COA (SP) 2015-015 REVISED
April 21, 2021

STAFF REPORT

SPECIAL CERTIFICATE OF APPROPRIATENESS REVISION FOR THE PROPERTY AT 6801 GRANADA BOULEVARD A LOCAL HISTORIC LANDMARK

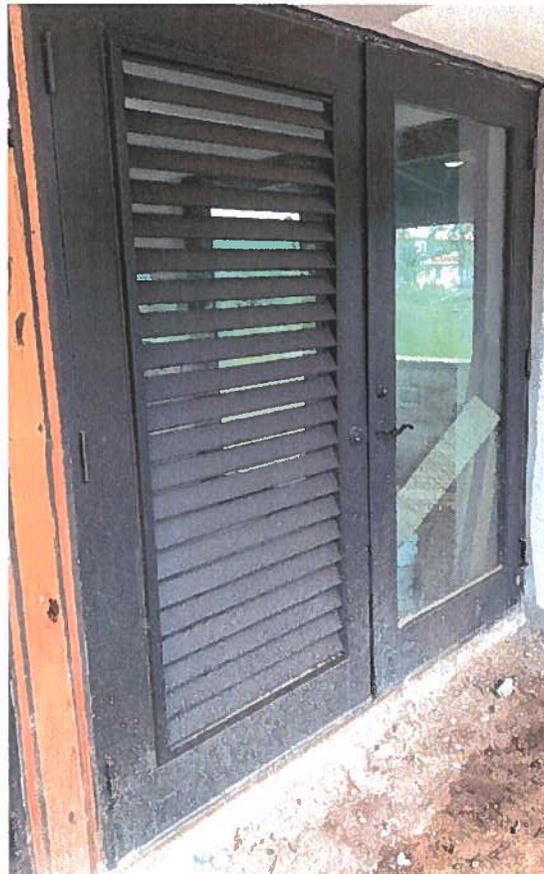
The original Persiana louver system was one of the Parker's signature features, which have now been removed. Staff commented on how the original Persians were to be reinstalled. The architect states in the letter of intent that the "original 1951 mahogany louvers could be resourced from the original material and re-purposed into the fenestrations of the new glazing...[and] utilizes the original louver material, shape, order, color, and arrangement...The design meets The Standards for Rehabilitation." Staff questions to which Standard the architect is referring.

The new windows and doors are the wrong color and have tinted/reflective glass. The louvers do not match the original in any way. They are the wrong size, color, density (number of louvers), and angle. Had the proper procedure been followed by the architect – revision followed by shop drawings – a proper solution might have been found.

Staff requires proof that the original Persiana louver system was retained. Are they being stored somewhere? Staff recommends denial of the window and door removal. New windows should be installed that reflect the material, clear window glass, and louver system as originally on the residence. Drawings should be prepared and permitted that detail the replacement to accurately match the original in size, color, number of louvers, and angle.

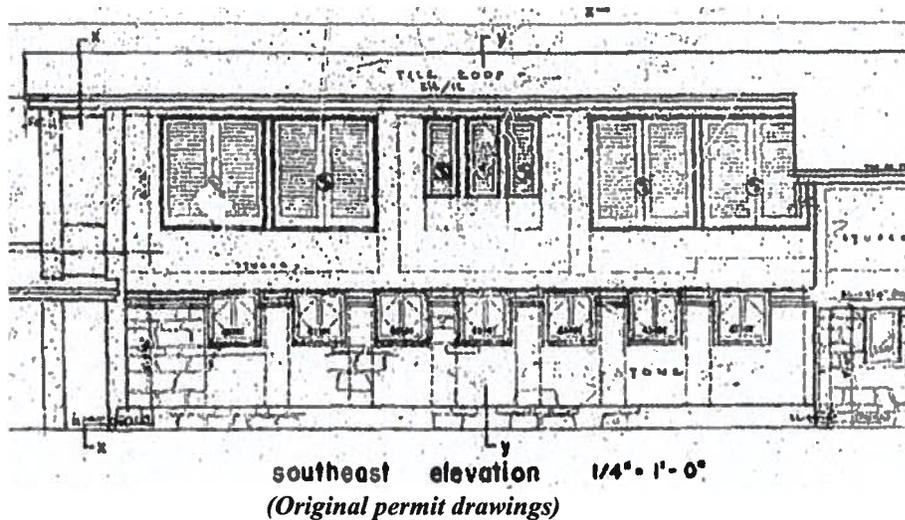
Staff’s initial note referred to the removal of an existing, to-remain wall that encircled the original pool location. While not original to the home, the stucco-clad wall was shown as to remain and was to screen the new air-conditioning units. The wall was removed. No details or elevations have been provided for its reconstruction.

The letter also mentions a planter that was removed to accommodate an “on-site sanitary treatment plant.” The oolite-clad planter was an original Parker-designed feature of the house and was shown as existing to remain. Staff has not been given any reason for why this planter had to be removed in part or in its entirety.

Staff recommends that drawings be prepared and permitted that detail the replacement of the coral planter to accurately match the original in pattern and dimensions. Staff requires that the installation be done by a coral stone mason or conservator approved by the Historical Resources and Cultural Arts Department Staff.
